Product Change Notification (PCN)

PCN #: 1A-2019

All changes have been applied to Sentrius sensor part numbers 450-0180, 450-0181, 450-0182, and 450-0183:

5.1 Top Level Part Number Changes (packaged kits)

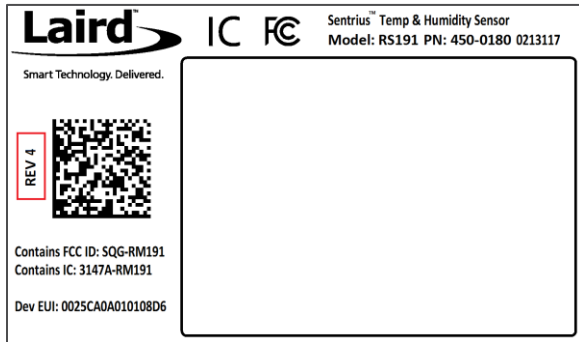
- Revision change available as revision number printed by barcode and (or) within the barcode for all kits (455-0001, 455-0002, 455-0009, and 455-0010).
- A black dot will also be seen on all kit labels by the barcode to indicate that the kit has been updated to the latest firmware.
